LONGWALLS 4 & 5 AND MAINGATES 6, 7 & 8

ADDENDUM TO RESPONSE TO SUBMISSIONS

November 2012

Figure 1 - LW 4 Subsidence Survey Monitoring Plan

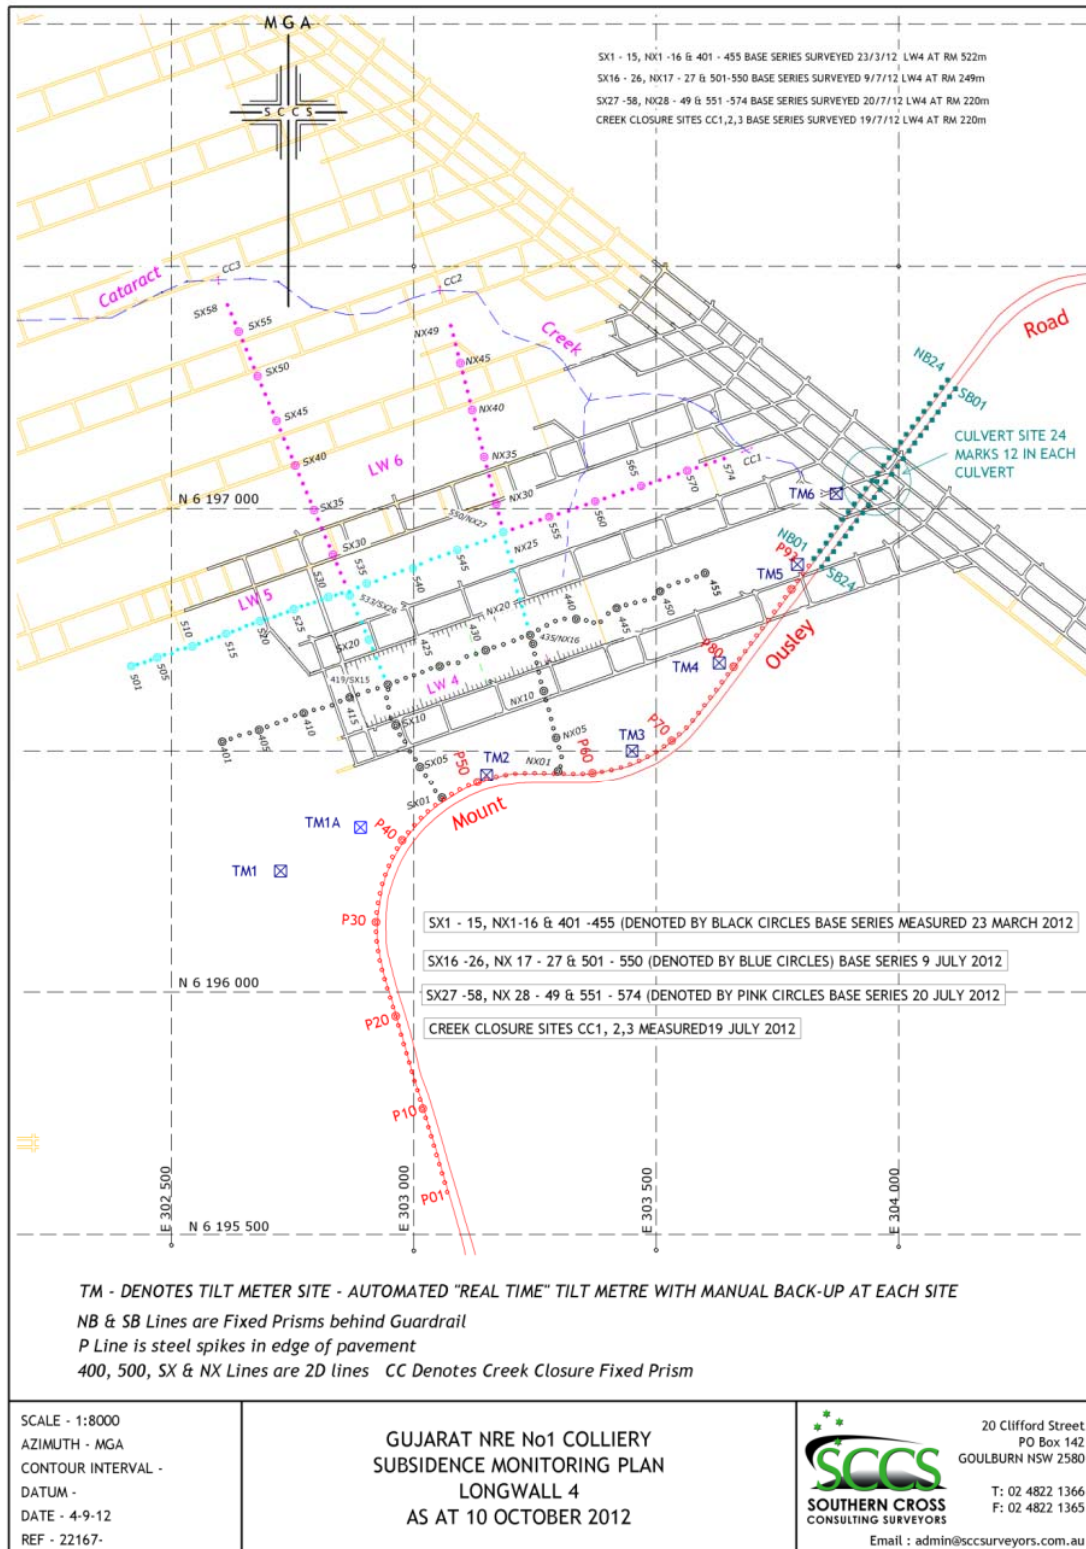
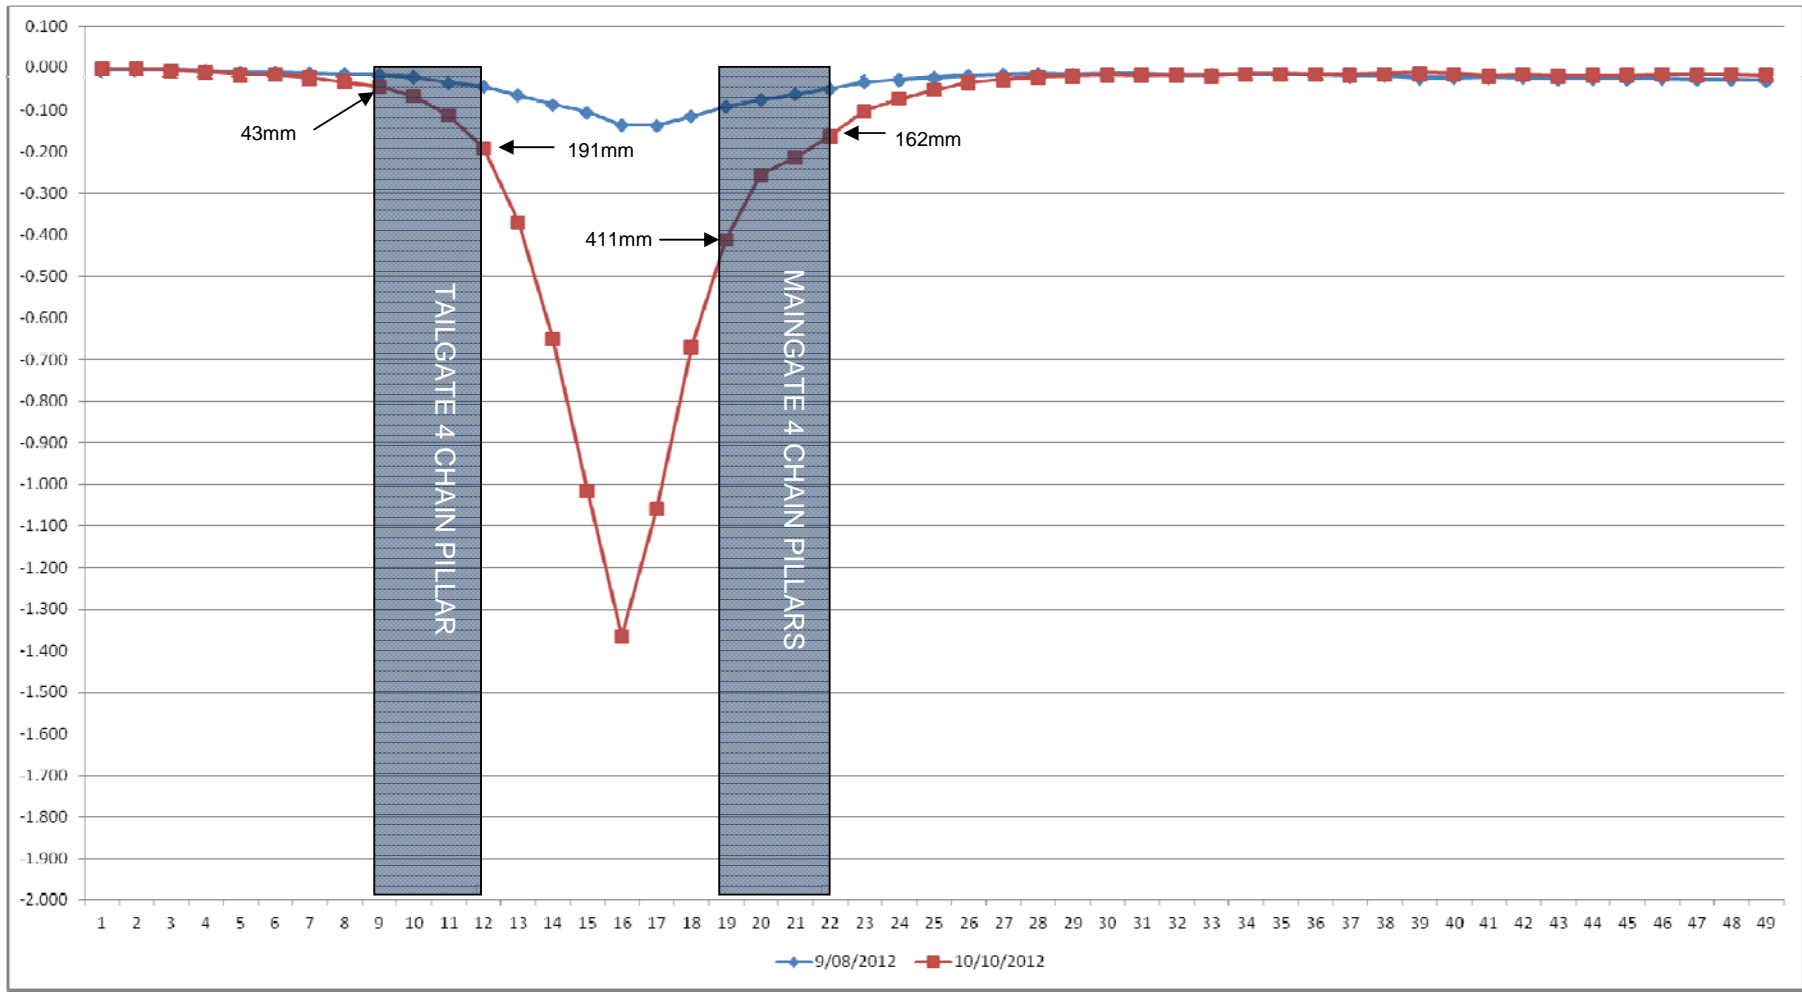
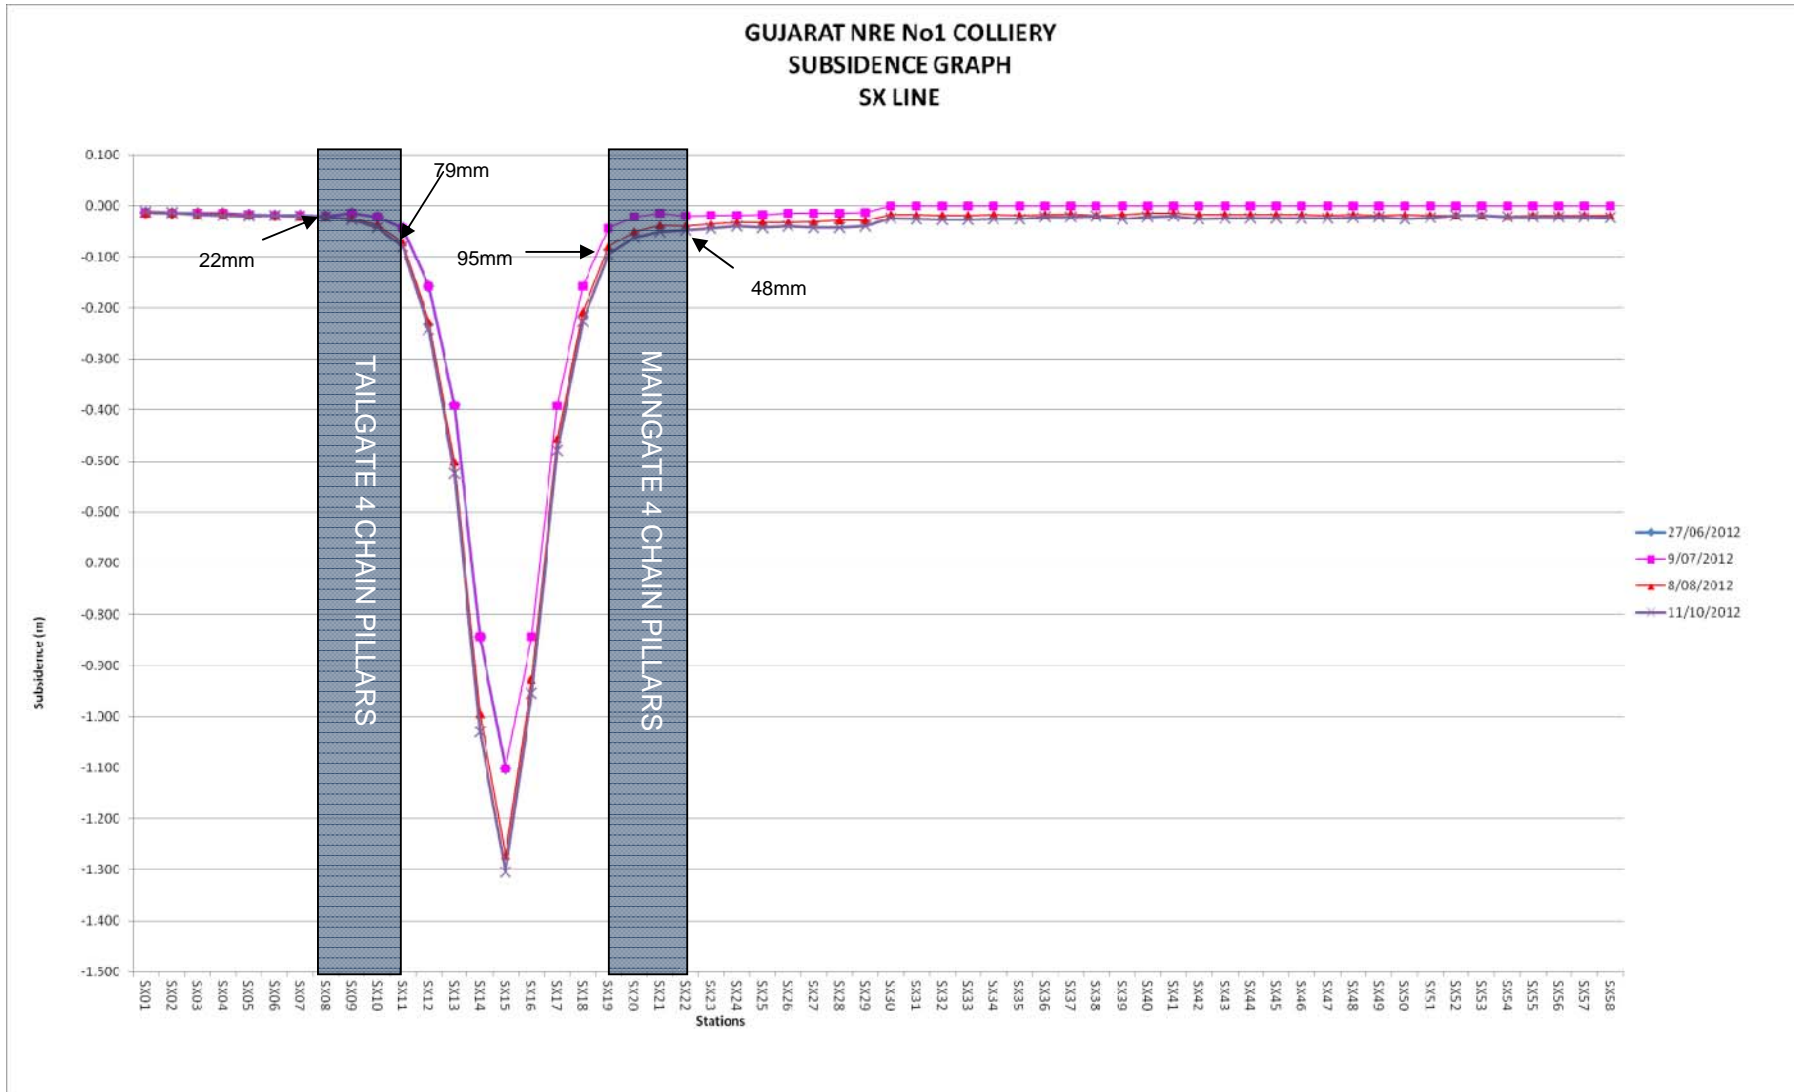
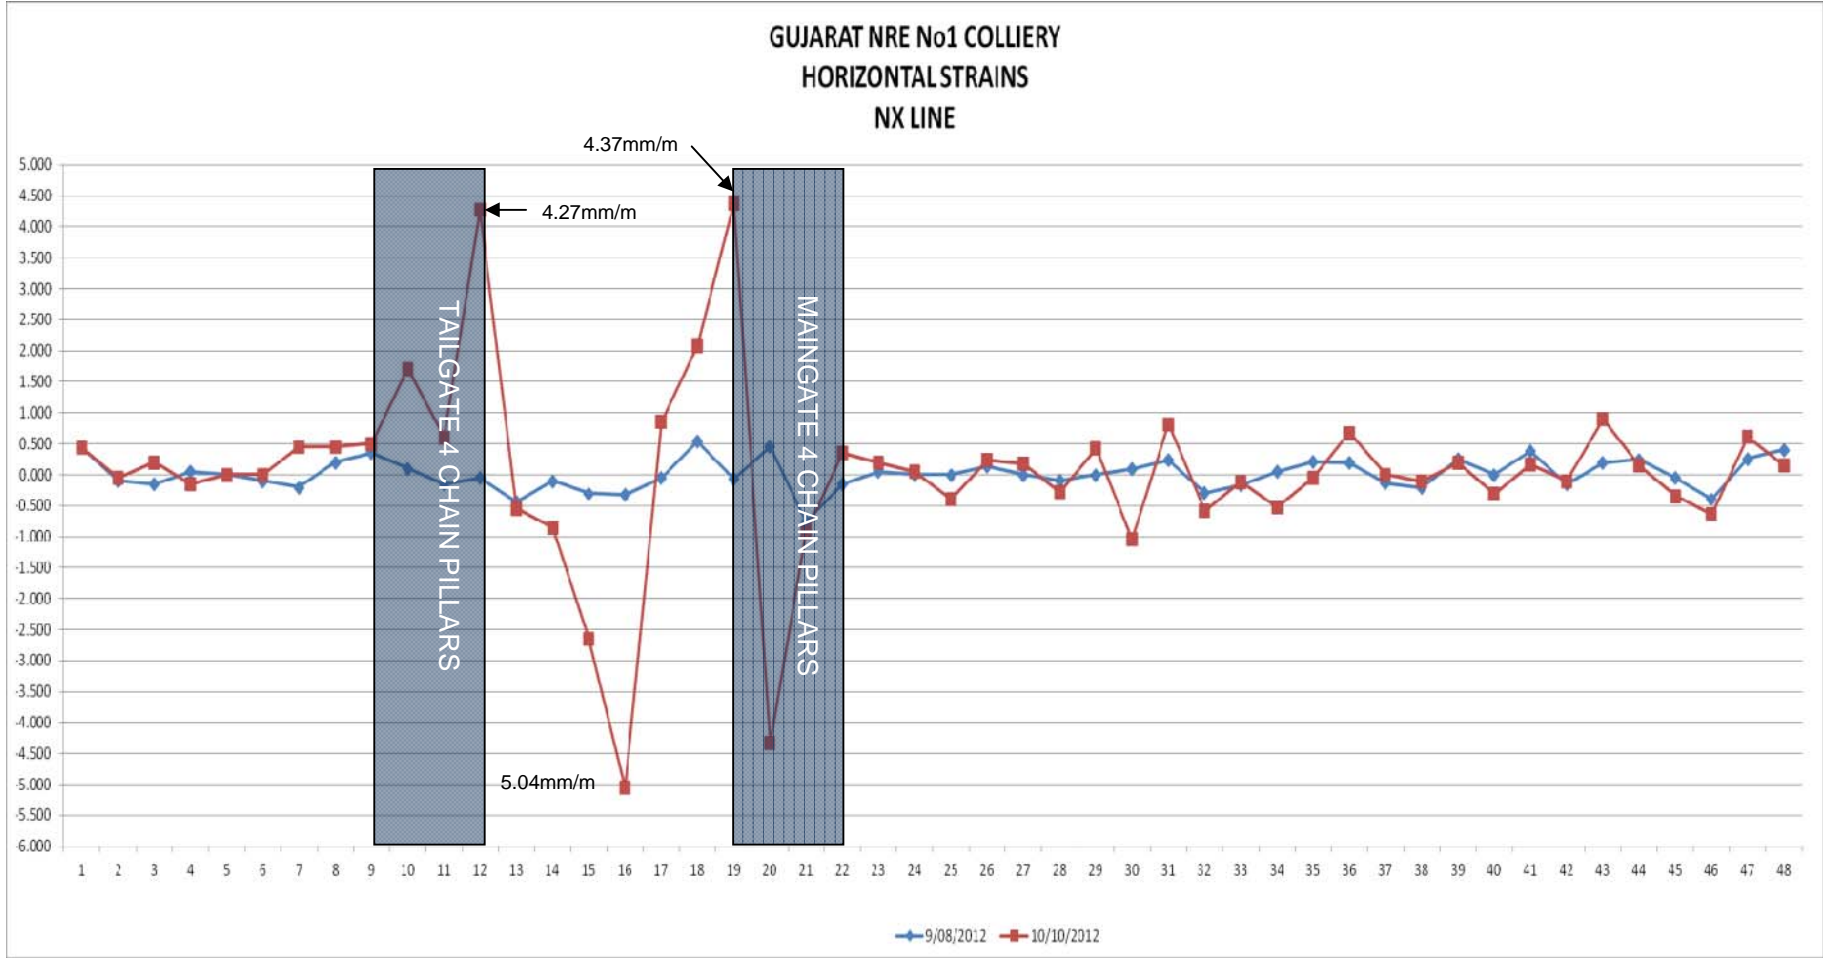
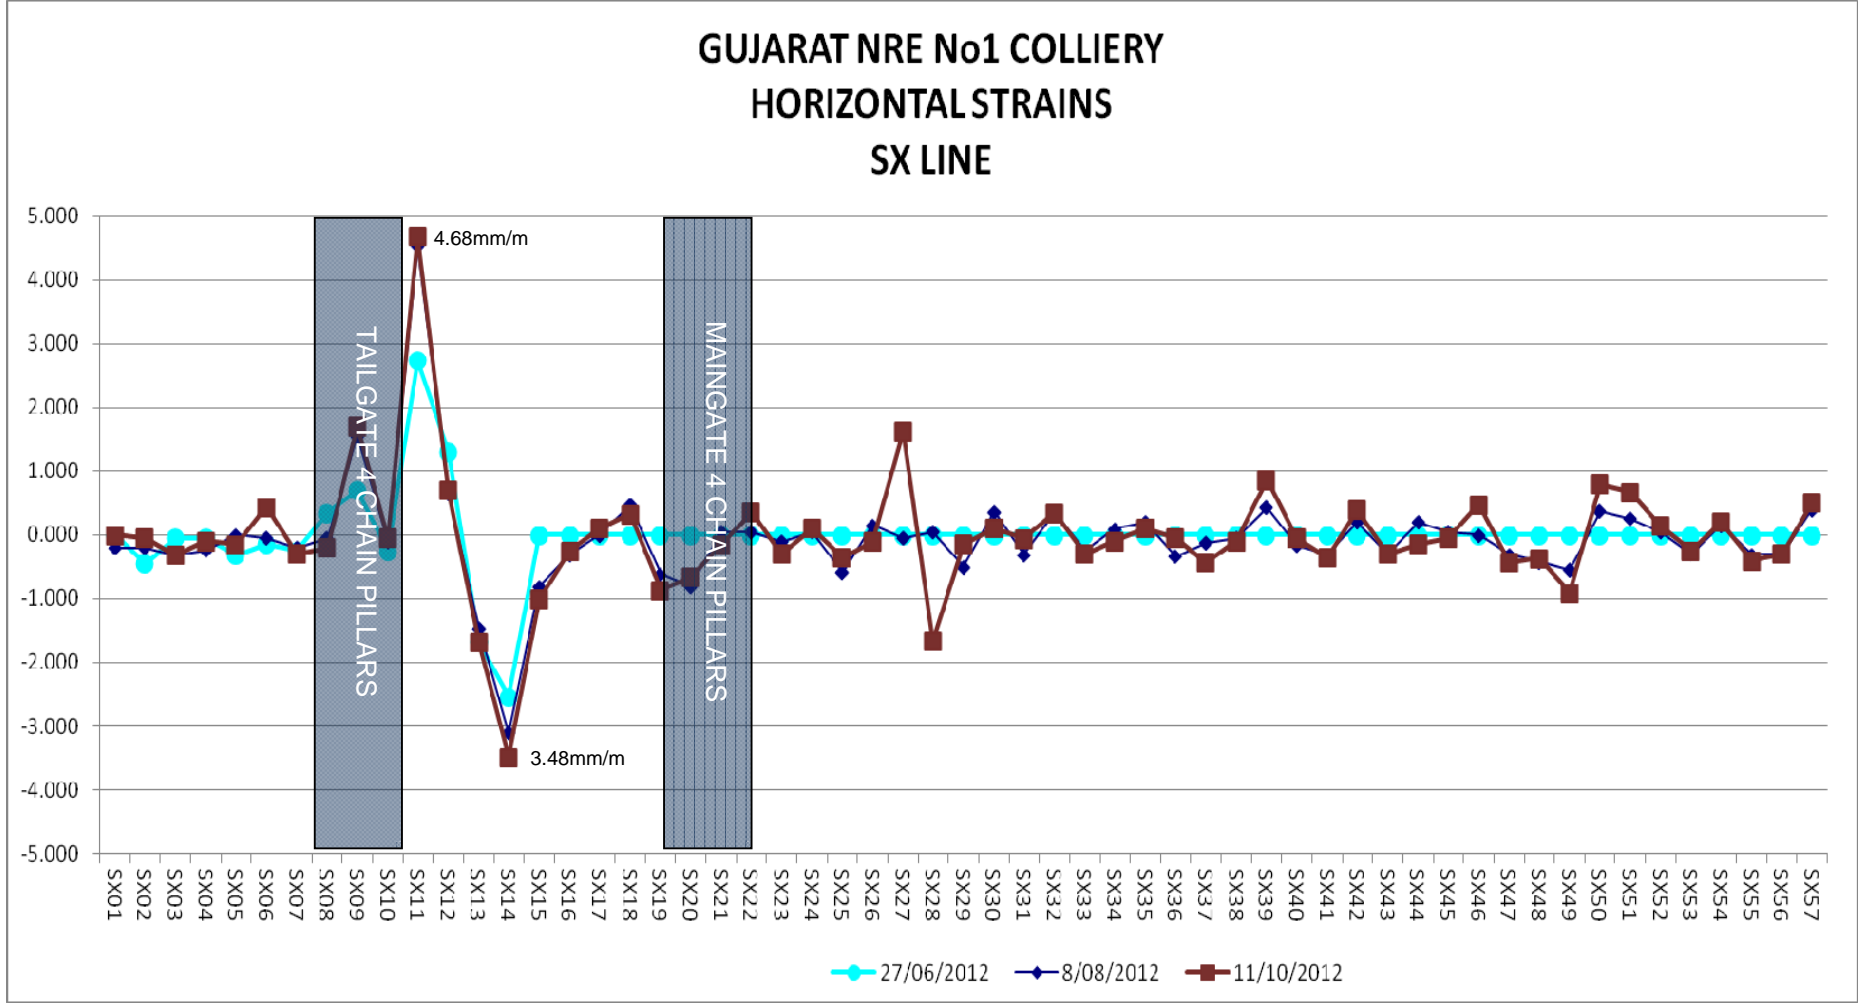
Lack of Updated Subsidence Predictions Based on LW4 Outcomes

NRE has been criticised for not updating subsidence predictions based on the outcomes of the LW4 subsidence monitoring.

The most recent data indicates that the maximum subsidence experienced over LW 4 was 1384mm (138.4cm or 1.384m). Predictions of subsidence for LW5 contained in Table 7.1 of the Longwalls 4 and 5; Maingates 6, 7 & 8 EA indicate a predicted maximum subsidence of 1.145m. This is a difference of 234mm (23cm or 0.23m).

Given that the geological conditions for LW5 are very similar to LW4 then the difference between the observed subsidence of LW4 and the predictions of LW5 are only in the order of 16% based on the **original subsidence predictions**. These original subsidence predictions for LW5 will be modified if necessary when final analysis of the subsidence monitoring data is completed by geotechnical experts.

The most important aspect that has been shown by the preliminary subsidence data is that the subsidence profile of LW4 is predominantly constrained to within the limits of the longwall panel mined in the Wongawilli Seam. The effect of the overlying Bulli Seam goaf is evident in the difference in behaviour between the north subsidence line (NX shown in **Figure 2**) where the Bulli Seam goaf extends either side of LW4 and the south subsidence line (SX shown in **Figure 3**) where the Bulli Seam goaf coincidentally extends only as far as the edges of the Longwall 4 goaf. The Balgownie Seam goaf is not evident in the subsidence profiles. Preliminary indications are that strains are confined to the inside edge of the chain pillars and the centre of the longwall as shown in **Figure 4** and **Figure 5**. The maximum observed horizontal tensile strain over the chain pillars was 4.68mm/m of tensile or expansive strain on the SX subsidence survey line. The maximum observed horizontal compressive strain was 5.03mm/m of compressive strain on the NX subsidence survey line. This compares favourably to the currently predicted 10-12mm/m maximum strain for LW5. **Figure 6** and **Figure 7** show that the vertical subsidence and strain are also constrained primarily to the LW panel with little extension beyond start and finish lines.
